Product Revision Notice:OWA/NPF/PWM Series &LPV/LPC/ LPVL-150 Series Case Revision

Models	NPF -90/120 series PWM -90/120 series OWA-60/90/120 series LPV/LPC -150,LPVL-150 series
Before	
After

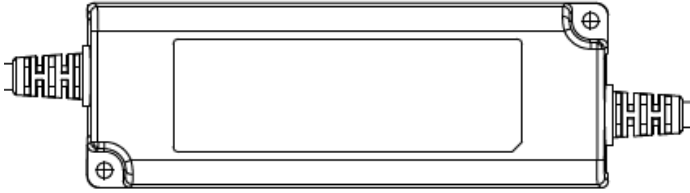
At present, there are two types of mounting holes, O-shape and U-shape. However, for wider application installation demands and shell integration, the mounting holes shape of OWA / NPF / PWM series & LPV /LPC/LPVL-150 series are changed to U-shaped.

Product revision for this time is to modify the appearance of the cabinet mounting holes, having no influence on the product installation size, safety and other performance. MEAN WELL takes in all relevant additional cost, making no adjustment on the price. Please refer to the following illustration for detailed revision. Shall there be any questions, please contact MEAN WELL sales representatives.
